February 4, 2019

**NOTICE OF ADDENDUM
 ADDENDUM NO. 1**

**CONTRACT NO. 8325
 PROJECT NO. 11399 SPRING HARBOR AT MASTHEAD (NAUTILUS POND)**

Insert
 Sheet D-1 (Rev. 02-04-2019)

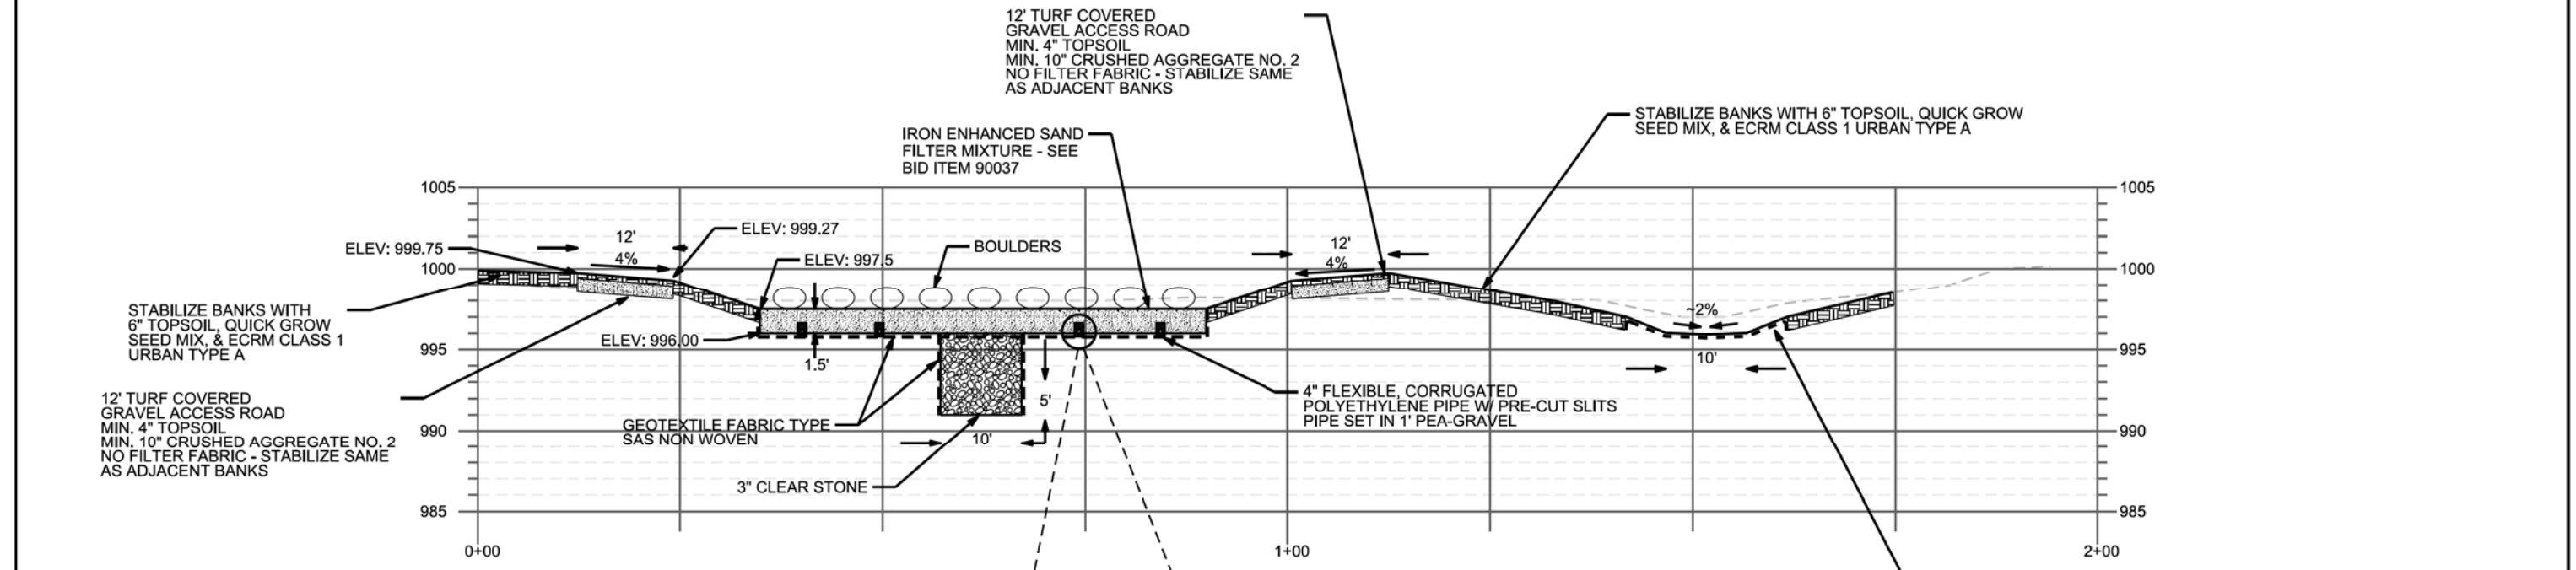
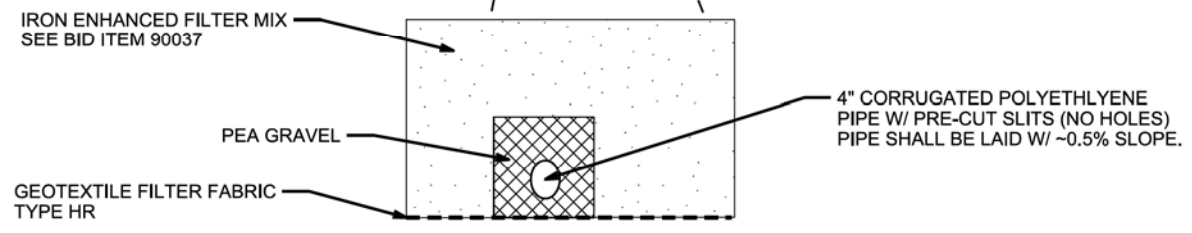
Remove
 Sheet D-1

NOTE:
 ALL STONE PLACED WITHIN THE CHANNEL SHALL BE PLACED SUCH THAT THE TOP STONE IS FLUSH WITH THE ADJACENT CHANNEL GRADE. STONES SHALL NOT BE SIGNIFICANTLY ELEVATED BEYOND THE CHANNEL.

AFTER GRADING CHANNEL, THE CONTRACTOR SHALL COMPACT THE CHANNEL BED WITH BUCKET TO STABILIZE BED MATERIAL. PLACE ECRM CLASS II TYPE C MATTING ON ALL BED SECTIONS NOT STABILIZED W/ RIPRAP.
